Agent response to GBC Horticulture Comments 6 February 2026

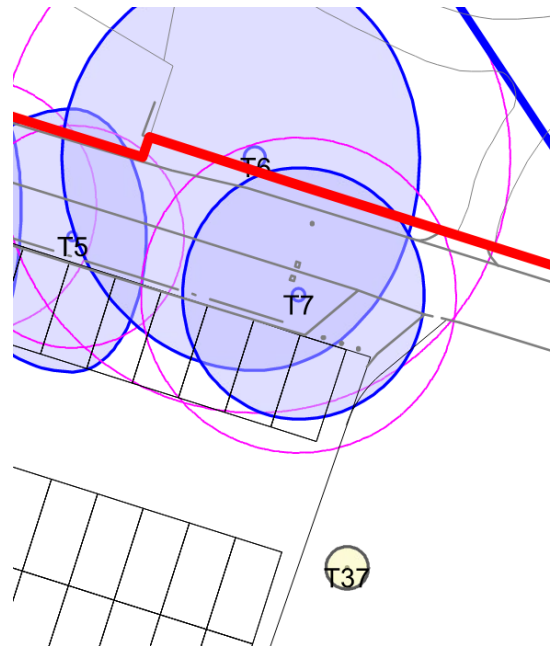
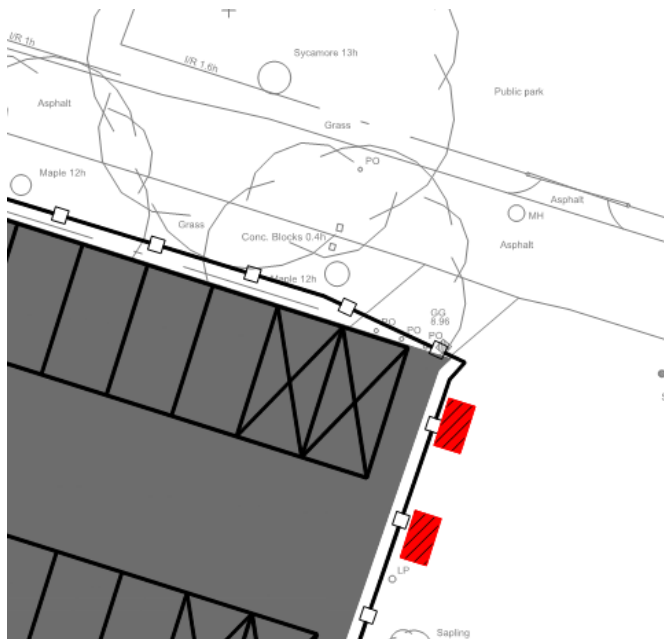
- Highlighted for removal are T53, G51 and T50, but these don't seem to be an obstruction to the planned development and sit on void land to the edge of the boundary. **T50 & G51 obstruct the proposed footpath as below on landscaping plan. T53 obstructs the proposed retaining wall foundations. See proposed landscaping in comparison to the arb extract:**

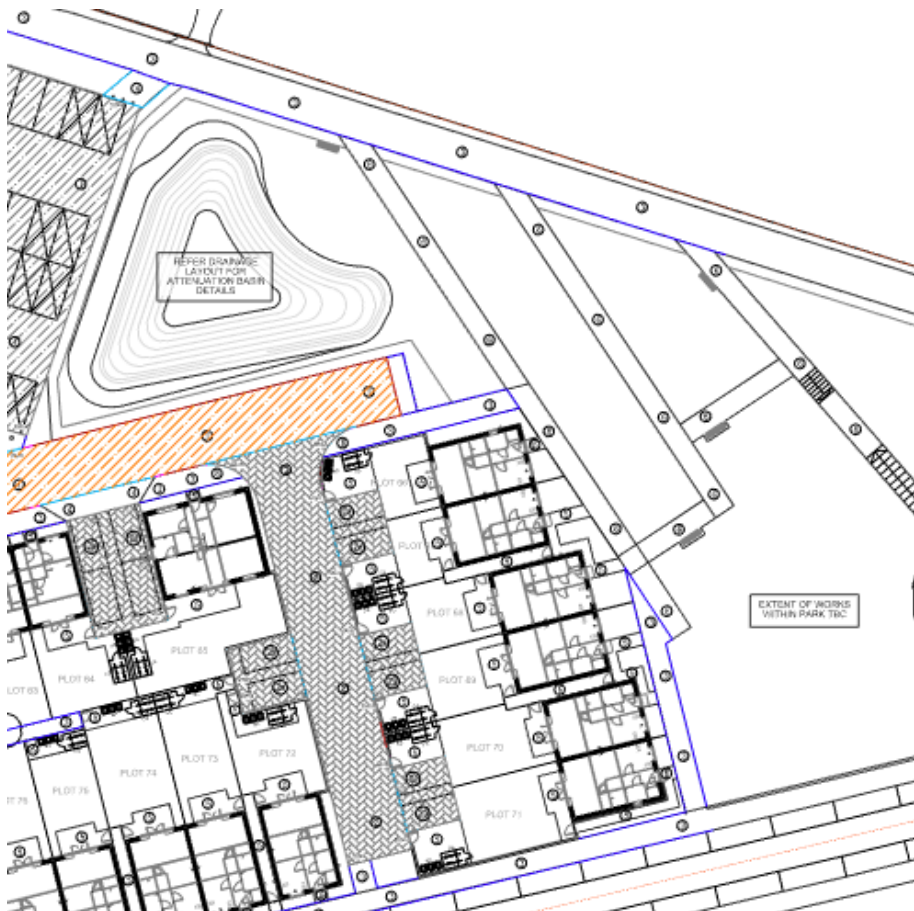
- To that point it would be good to know the plans for this section of land adjacent to Milton Place. **As seen above.**
- T7 has been suggested for a crown lift but I not sure why access would be required from this edge of the car park. **Large HGV access has been included within the car park design, as they have used this route for previous fairs etc that occur in the field behind – therefore, T7's crown lift will be required due to the size of vehicles travelling near/under the tree. See proposed car park plan against arb extract:**
